**Re: Response to Council Interrogatories  
PETITION NO. 1592A - Santa Fuel, Inc. petition for a declaratory ruling,  
pursuant to Connecticut General Statutes §4-176 and §16-50k, for the  
proposed construction, maintenance and operation of a 3.575-megawatt AC  
solar photovoltaic electric generating facility located at the 159 South Road,  
Somers, Connecticut, and associated electrical interconnection.**

**RESPONSES TO THE DECEMBER 17, 2024 PRE-HEARING INTERROGATORIES  
DIRECTED TO SANTA FUEL, INC. FROM THE CONNECTICUT SITING COUNCIL**

**ATTACHMENT 1**  
**Revised Sight Line Demonstration Plan**

**Mountain View Rd  
Access Drive  
Sight Line  
Demonstration Plan**

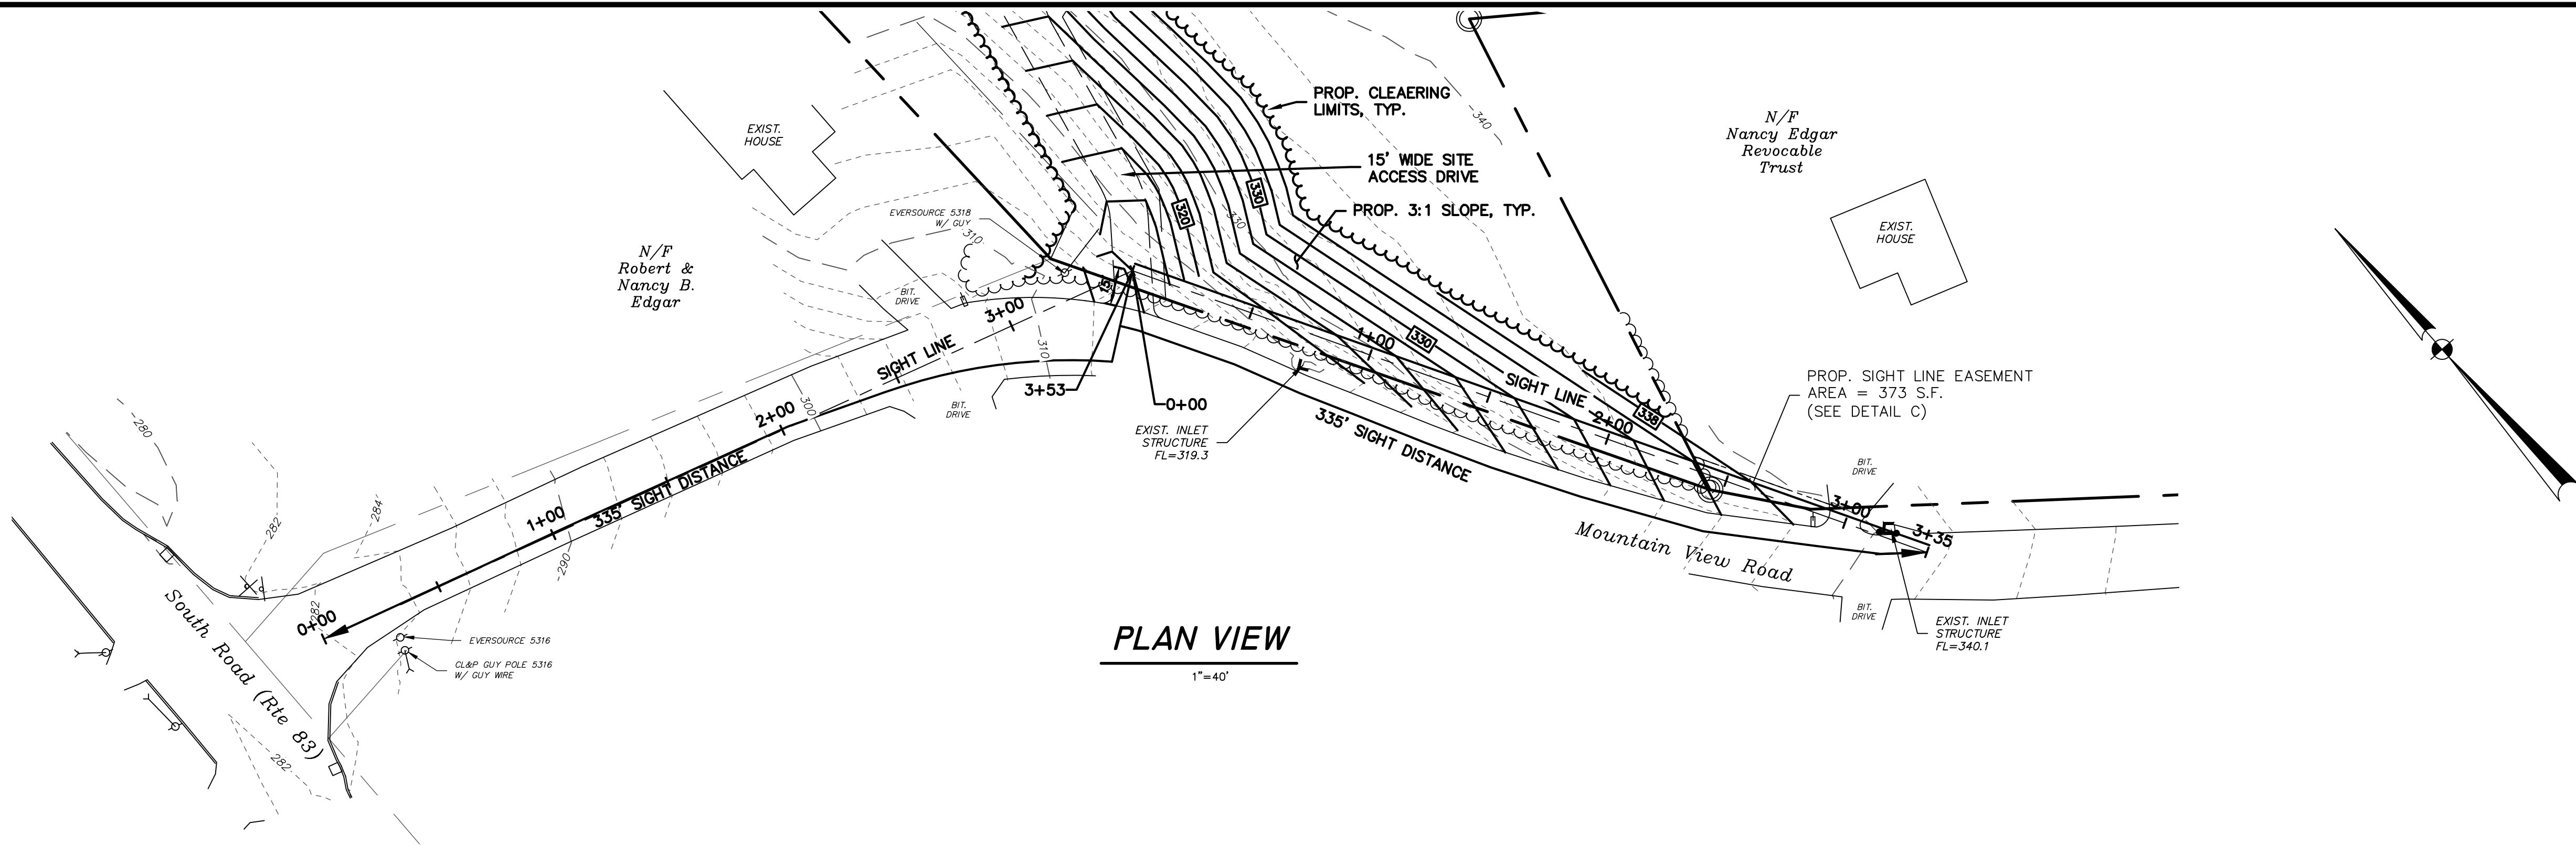
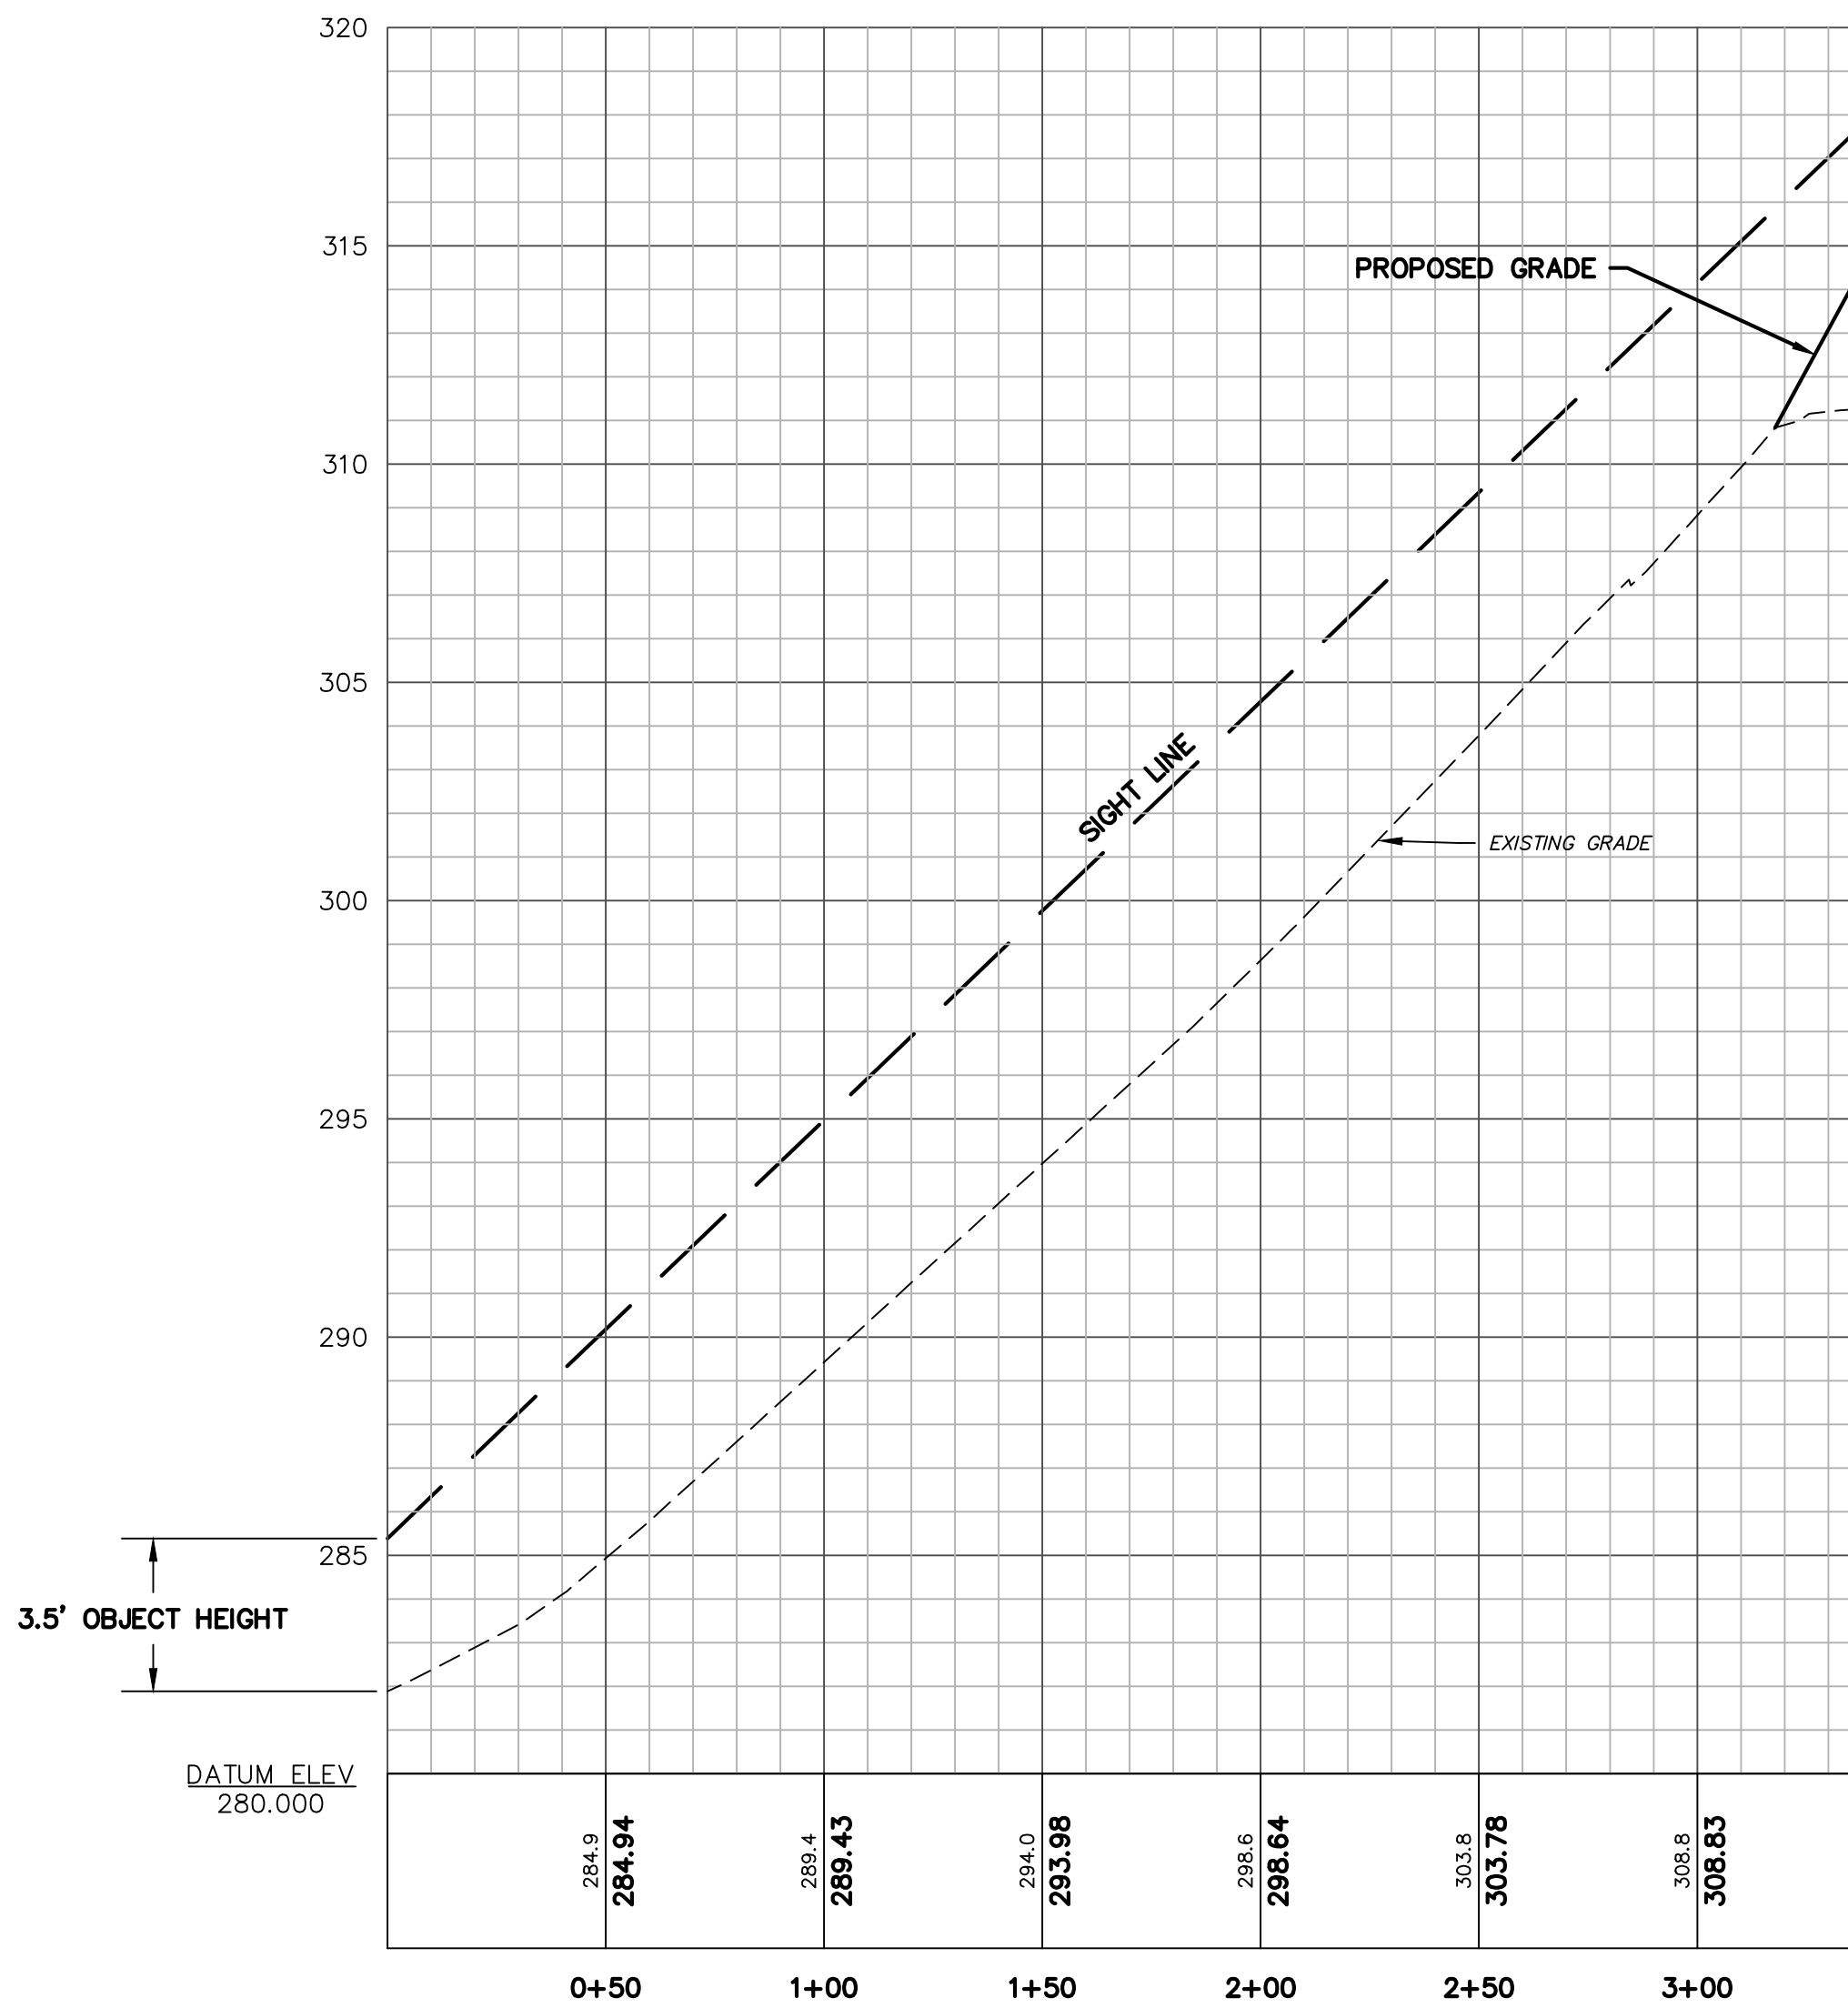
13. Referencing Motion to Reopen p. 4 and the Sight Line Demonstration Plan behind Attachment A, what is the basis for the standards that were used for the sight line criteria (ex. Connecticut Department of Transportation requirements, Eversource Energy requirements)?

- A. The required sight distance was calculated in accordance with the Connecticut Department of Transportation Highway Design Manual procedures for intersection sight distance (ISD). A revised Sight Line Demonstration Plan is provided as Attachment 1. Upon review, it was determined that the slope factor adjustment applied to the initial ISD calculation is not warranted. The plan was revised to provide the correct ISD criteria. The revised Plan indicates that the required ISD is still provided at the proposed driveway. However, the revision resulted in a reduction in the size of the Easement required across the property at 23 Mountain View Road.
